MM11

FIELD SERVICE TECHNICAL MANUAL				Option or Designator
	12 Bit <input type="checkbox"/>	16 Bit <input checked="" type="checkbox"/>	18 Bit <input type="checkbox"/>	36 Bit <input type="checkbox"/>	MM11

Engineering Change Order Log

ECO MM11F
MM11F REWORK SHEET

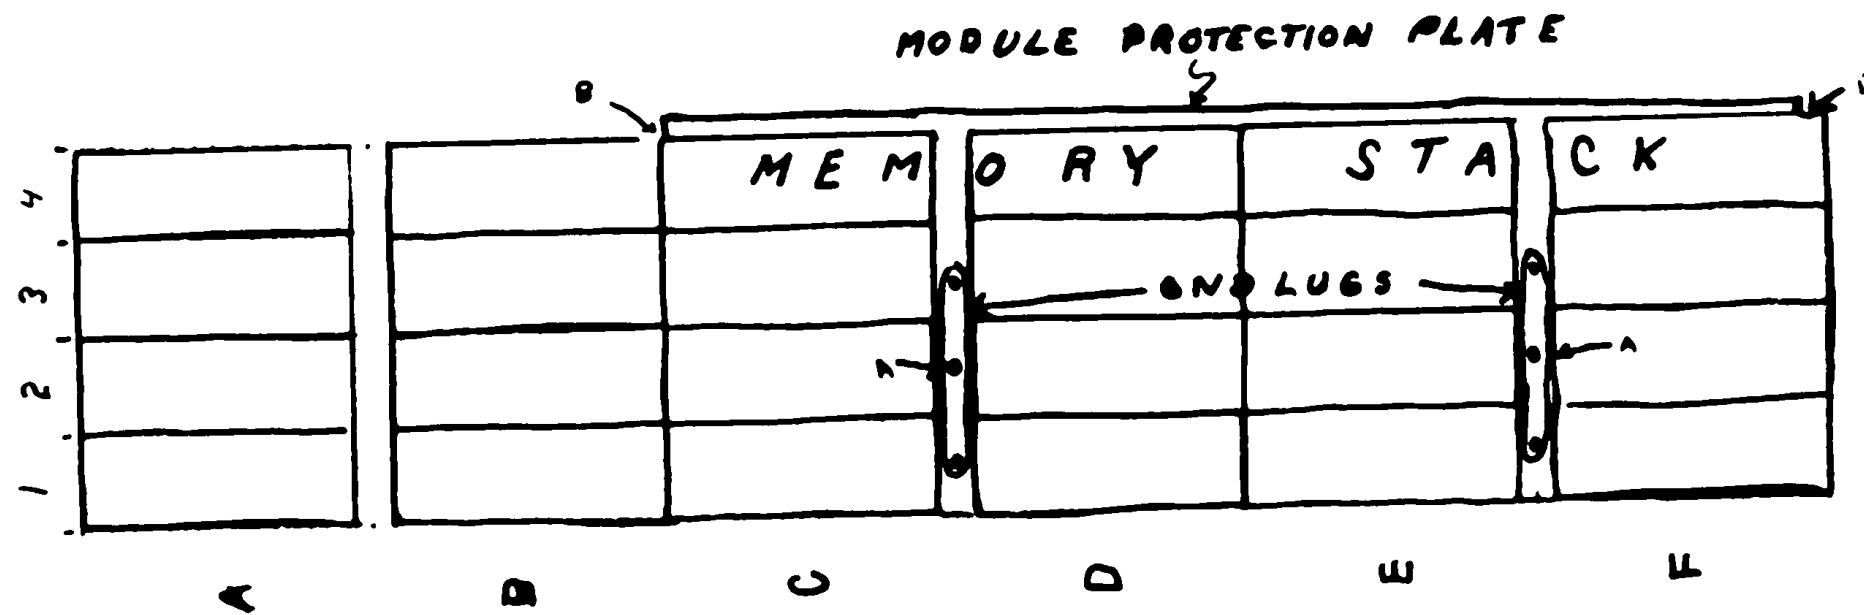
1. LOOSEN 2 SCREWS AT POINTS A, CARE SHOULD BE USED AT ALL TIME SO THAT NO WIRES WILL BE DAMAGED.
2. SLIDE THE FINGERS OF THE MODULE PROTECTION PLATE UNDER THE END LUGS. THE PROTECTION PLATE SHOULD BE RIGHT AGAINST THE WIRED ASSY. FRAME, POINTS B.
3. TIGHTEN SCREWS.

ECO NO MM11F-00003

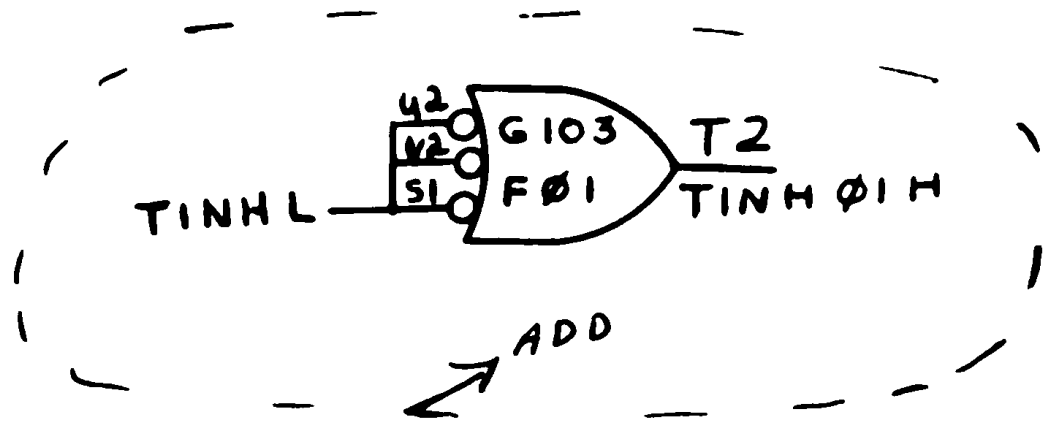
SIGNAL NAME	FROM PIN	TO PIN	COMPONENTS	ADD	DEL
TINH H	C01C1	D02E1			X
TINH H	D03E1	E03E1			X
TINH H	E01E1	F01E1			X
STROBE 0 H	C01R1	D02S1			X
STROBE 01 H	C01A1	E01S1			X
TSS H	F01V2	F01P1			X
TINH L	C01K1	F01S1		X	
TINH L	F01S1	F01U2		X	
TINH L	F01U2	F01V2		X	
TINH 0 H	C01C1	D02E1	WHT	TWP	X
GND	C01C2	D02C2	RED		X
TINH 01 H	F01T2	F01F1	WHT	TWP	X
GND	F01T1	F01C2	RED		X
TINH 01 H	F01T2	E02E1	WHT	TWP	X
GND	F01T1	E02C2	RED		X
STROBE 0 H	C01R1	D02S1	WHT	TWP	X
GND	C01T1	D02T1	RED		X
STROBE 01 H	C01A1	E01S1	WHT	TWP	X
GND	C01C2	E01T1	RED		X

MM115 REWORK SHEET

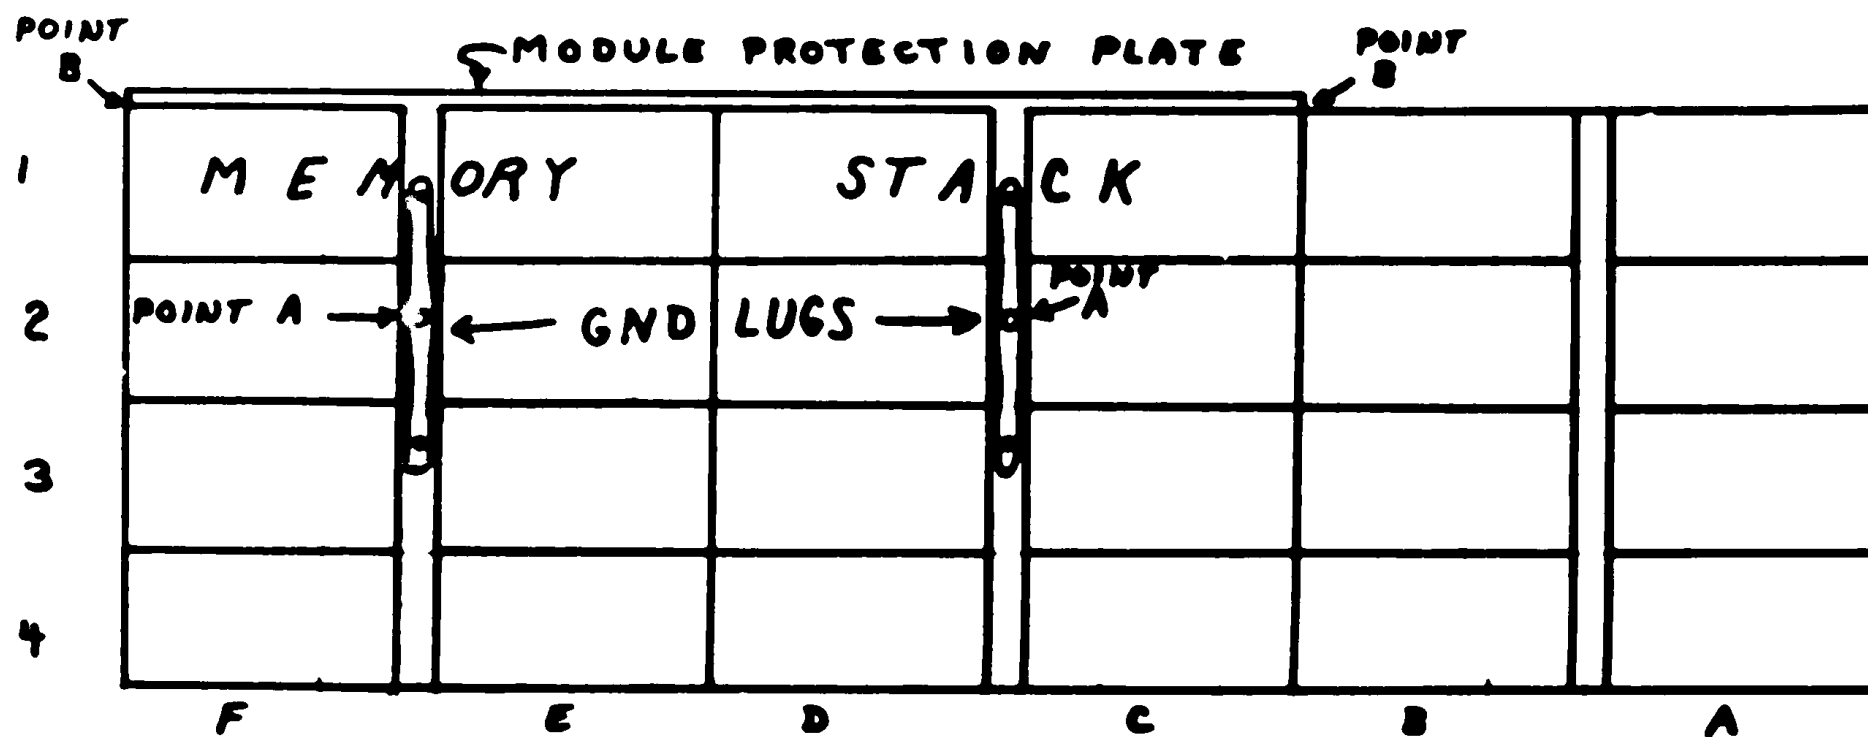
1. LOOSEN 2 SCREWS AT POINTS A. CARE SHOULD BE USED AT ALL TIME SO THAT NO WIRES ARE DAMAGED.
2. SLIDE THE FINGERS OF THE MODULE PROTECTION PLATE UNDER THE GND LUGS. THE PROTECTION PLATE SHOULD BE RIGHT AGAINST THE WIRED ASSY. FRAME, POINT B.
3. TIGHTEN SCREWS.
